## RamKeeper Modification for Apple IIGS 1 Meg (Rev. 3 Motherboard)

Because of the new board layout of Apple's new IIGS 1 Meg (Rev. 3 motherboard), we've had to modify a chip on the RamKeeper. If you have Apple's new IIGS 1 Meg, the RamKeeper in this package is ready to be installed. If you have the earlier IIGS, the RamKeeper requires a single chip swap to work.

### Apple IIGS Models

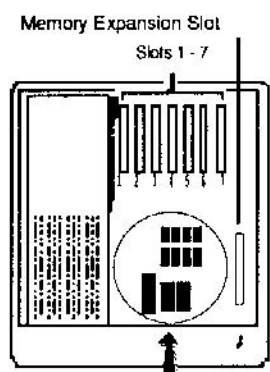
Earlier IIGS Motherboards  
No memory chips,  
1 ROM next to CPU

Rev 3 IIGS Motherboards  
8 memory chips,  
2 ROMs next to CPU

Swap the 74F27  
if you have the earlier IIGS

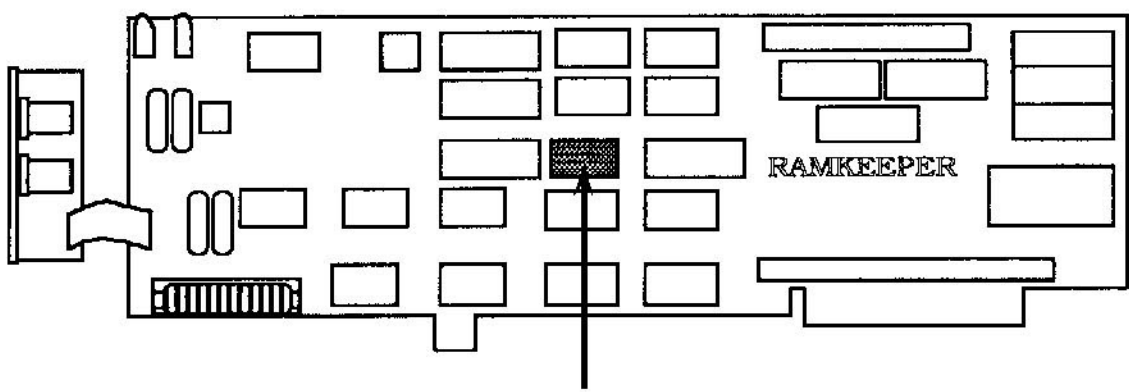
If you have the *earlier* GS, substitute the 74F27 chip shown below.

If you aren't familiar with the process of changing chips, refer to the "Chip Replacement Instructions" sheet included in the chip package.
